PUMP STATION SITE
TRACT 2A

**EAST PARK ESTATES
A P.U.D.
PHASE 2**

Class 3-Site Plan Review

**SUBJECT: PUBLIC WORKS RECOMMENDATIONS
SPR-ADJ-DAP 20-42 (20-116092)
255 CORDON ROAD NE
AUBURN PUMP STATION**

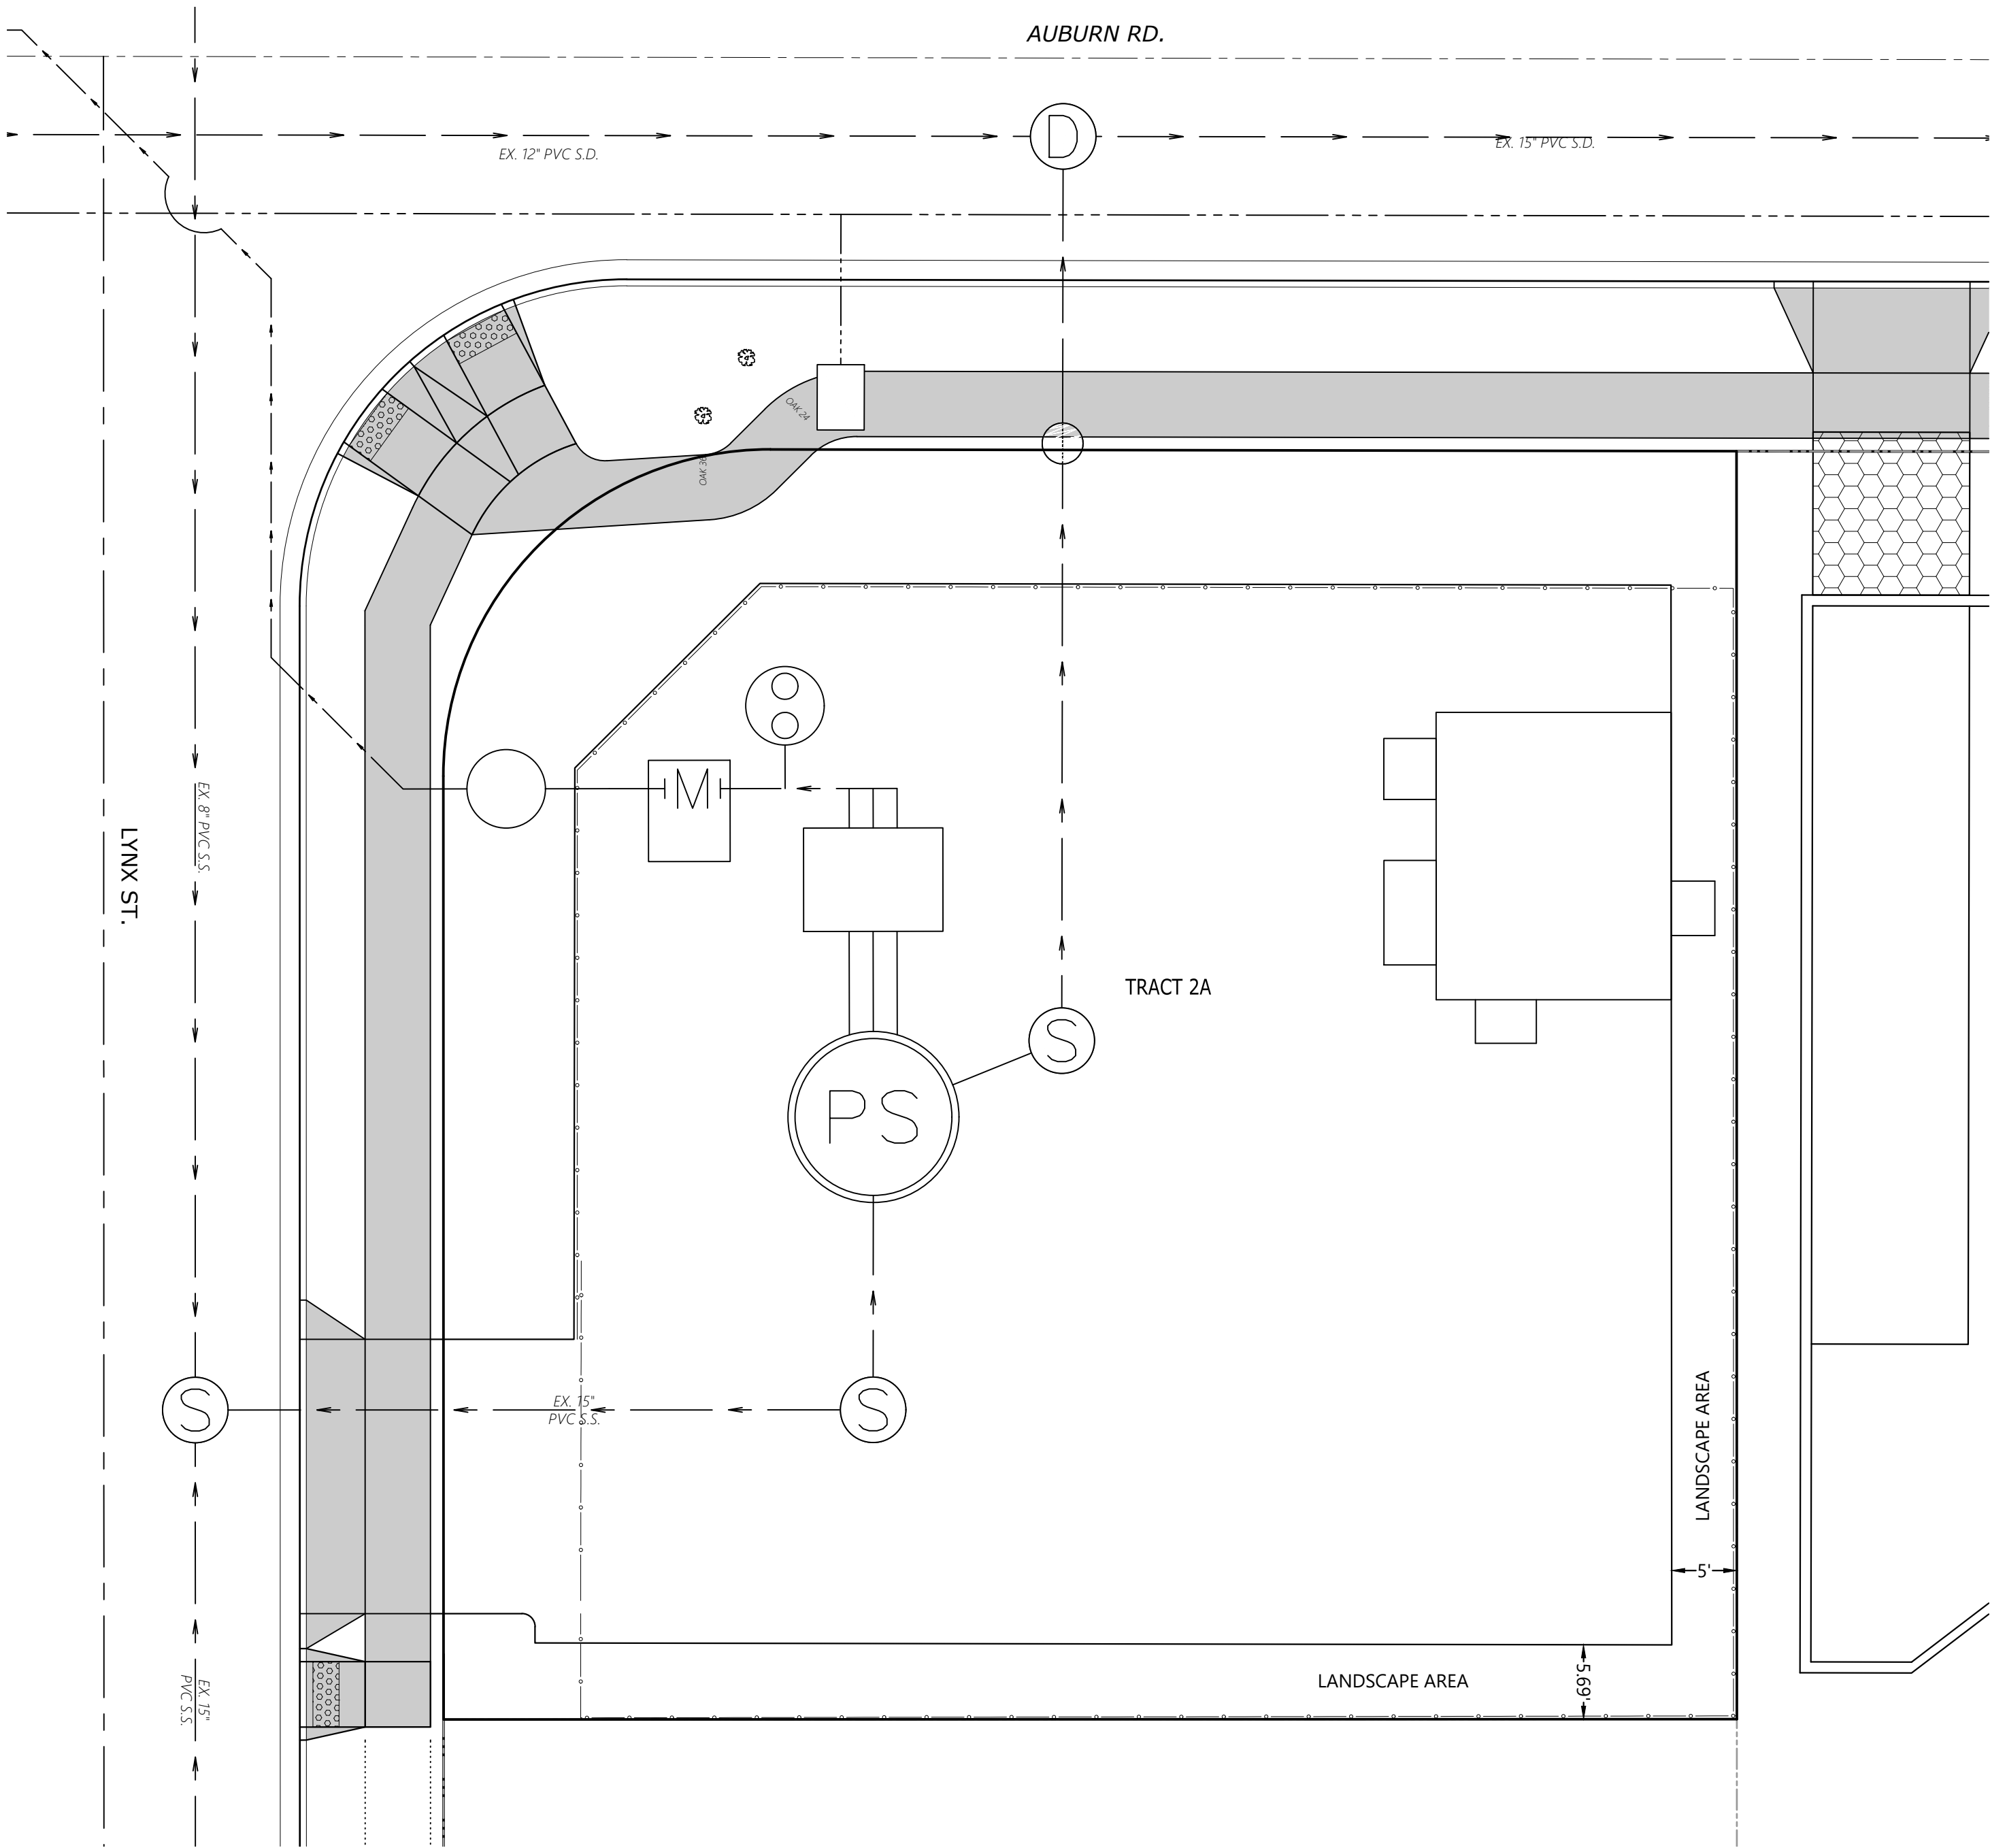
1. Construct a three-quarter street improvement along the frontage of Redmond Street NE to Local street standards, including all utilities that are planned within this portion of the street.
2. Construct sidewalk and street trees along the frontage of Auburn Road NE.

Finding—The existing condition of Auburn Road NE does not meet current standards for its classification of street per the Salem TSP. Sidewalks and street trees are required along the Auburn Road NE frontage. The proposed development shows driveway access to be taken from Redmond Street NE, a future private street. The applicant shall construct a three-quarter street improvement along the Redmond Street NE frontage to local street standards as specified in the PWDS and consistent with the provisions of SRC Chapter 803, including all utilities that are planned within this portion of the street.

Finding—The driveway access onto Redmond Street NE provides for safe turning movements into and out of the property.
